**ADDENDUM NO. 1
TO
INVITATION FOR BIDS**

**IFB-16-HHL-007
INDIVIDUAL WASTEWATER SYSTEM REPLACEMENT,
LALAMILO PHASE 1, LOT 1**

ADDENDUM NO. 1

Figure 1

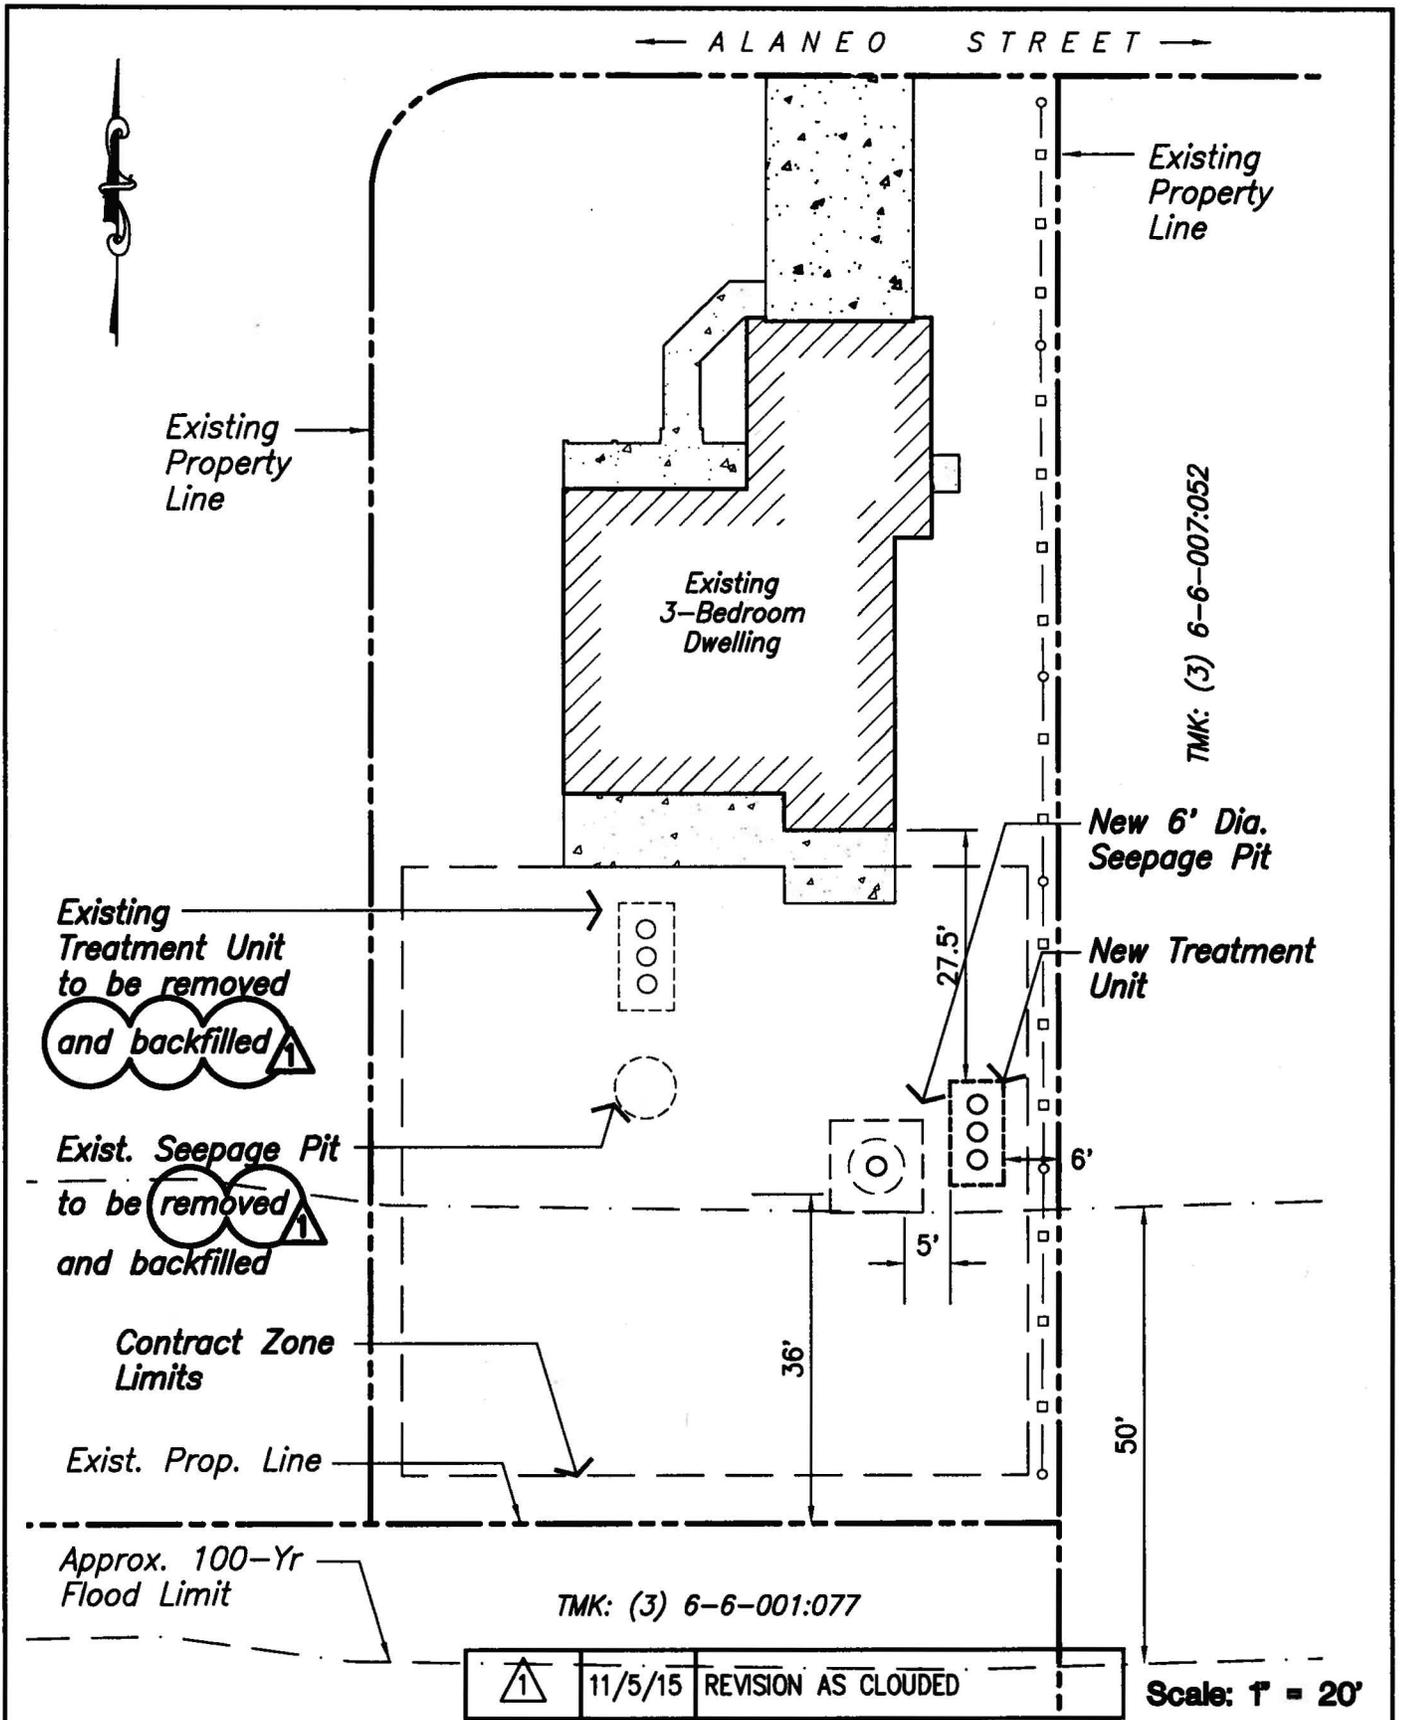
1. Pre-Bid Conference Agenda; Pre-bid Conference, October 29, 2015, at Hale Kuhio, 64-756 Mamalahoa Highway, Waimea, Hawaii 96743;
2. Sign-In Sheet (Pre-Bid Conference, on October 29, 2015)
3. Overall Site Plan (Figure 1) and Septic System Site Plan (Figure 2) for the Individual Wastewater System Replacement shall be replaced with the revisions, dated 11-5-15. (Enclosed).
4. Sections 02060-1 to 02060-3; Pumping and Backfilling of Cesspools in the Technical Specifications shall be replaced with revisions, dated 11-5-15. (Enclosed)

GRADING PLAN
SCALE: 1" = 50'

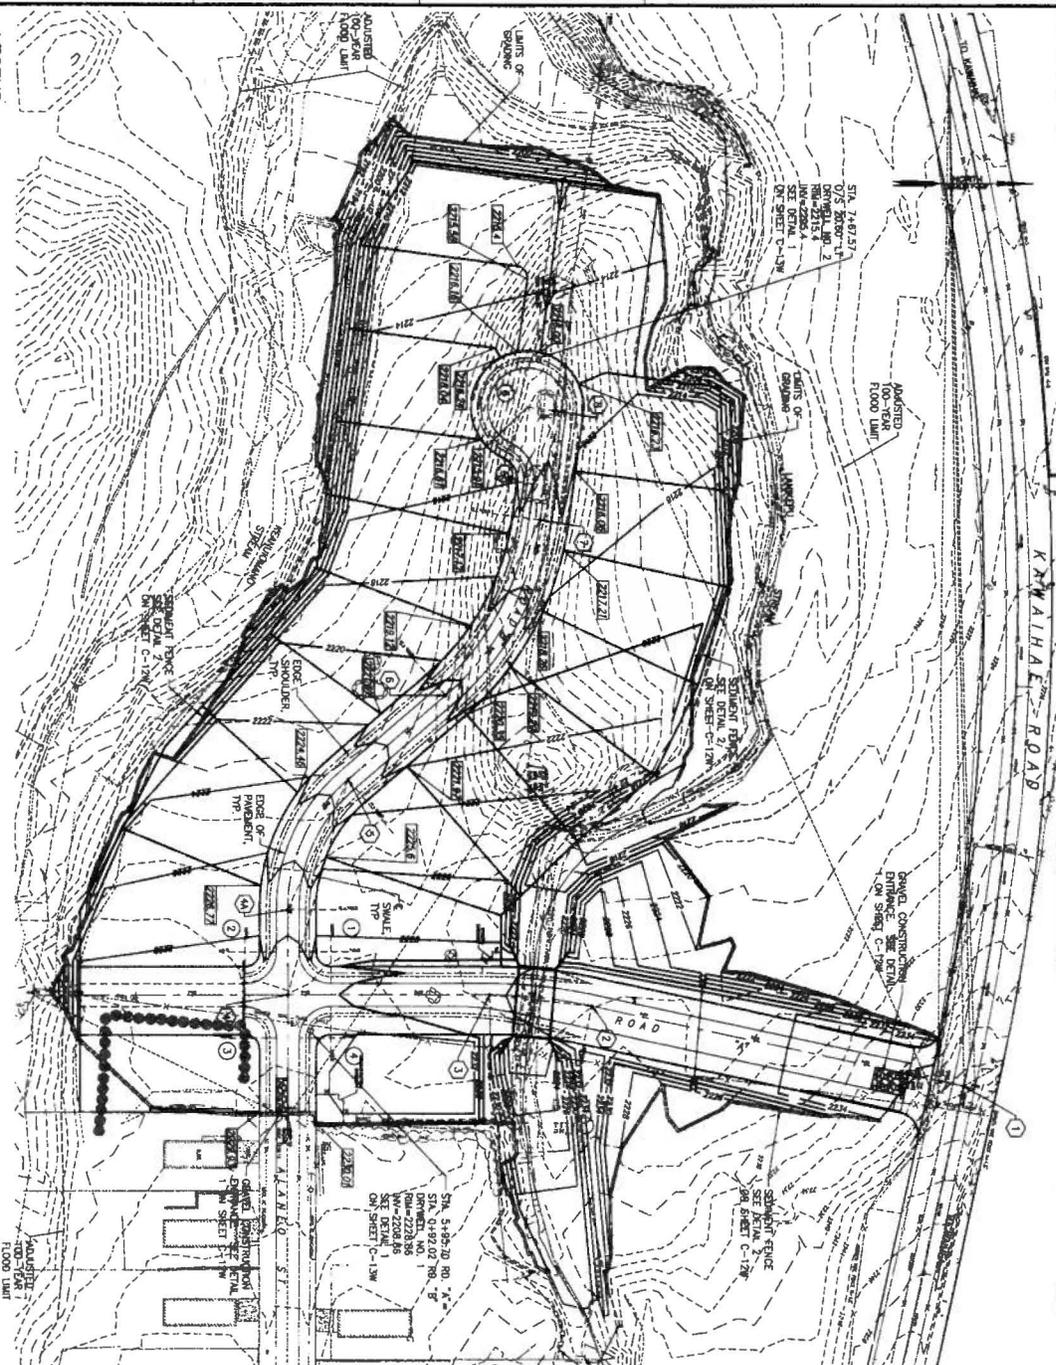
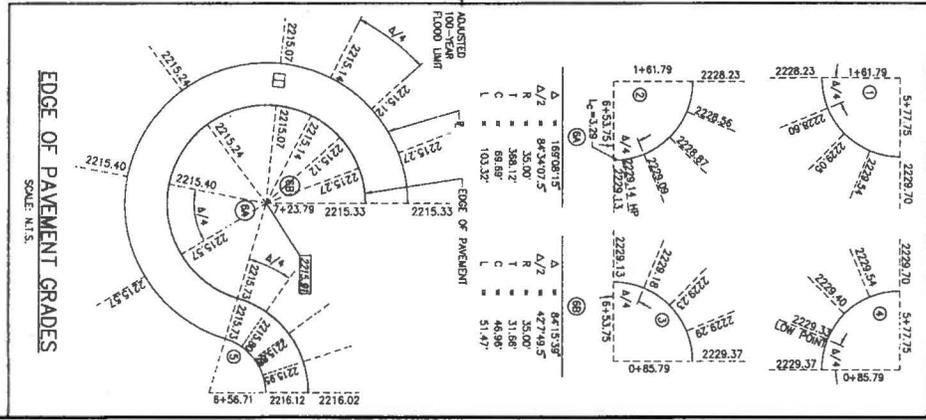
- A) The original specification for New Aerobic Treatment Unit, "ESIS Model 1300 or approved equal" shall be replaced with "ESIS Model 1700 or approved equal with 1,000 gpd rating minimum"; And,
 - B) The abandonment and backfilling of the existing seepage pit (cesspool) has been replaced with specifications to excavate, remove and backfill.
4. Pages 3 and 4; Bid Offer Form, revised 11/5/15. (Enclosed);
 5. Grading Plan; Lalamilo Housing West Subdivision Phase 1 (April 2005).

* The Grading Plan is for reference only. Contractor shall be responsible to determine the substrate.
